Access Compliance Report

Public Rights-of-Way (Curb Ramps)

| Intersection ID: 10025574 | Main Street: E_W_T_HARRIS_BV | Cross Street: N/A | Location: NW |
| ADA ID: 83C077ED8E9A | Ramp Type: Combination1 | Initial Pass/Fail: Fail | Overall Compliance: No |

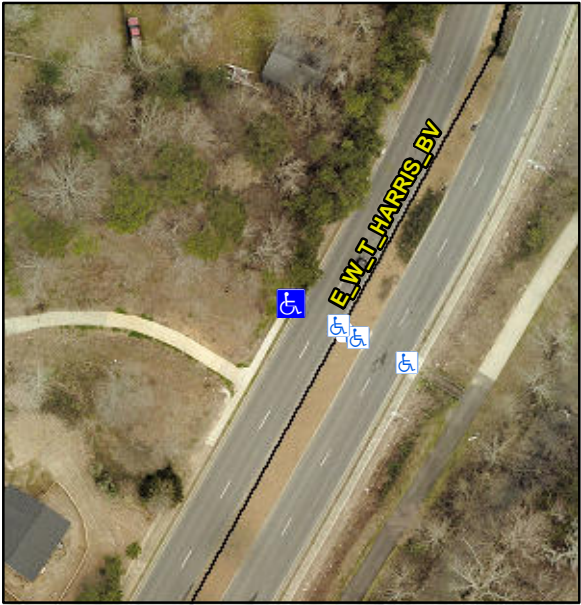
| Codes/Mitigation Info/Possible Solution | | | Field Measurements/Component Compliance | | |
|---|-------------------------------|--|---|-----------------------------|-------------|
| | Remove & Replace Sidewalk. | | No | Ramp Width LT (in) | 47.0 |
| <p>PROW/ADA:</p> <p>Not Found, R304.5.1</p> | | | N/A | Landing Length (in) | N/A |

| Codes/Mitigation Info/Possible Solution | | | Field Measurements/Component Compliance | | |
|---|-------------------------------|--|---|-----------------------------|-------------|
| | Remove & Replace Entire Ramp. | | N/A | Ramp Length LT (in) | 75.0 |
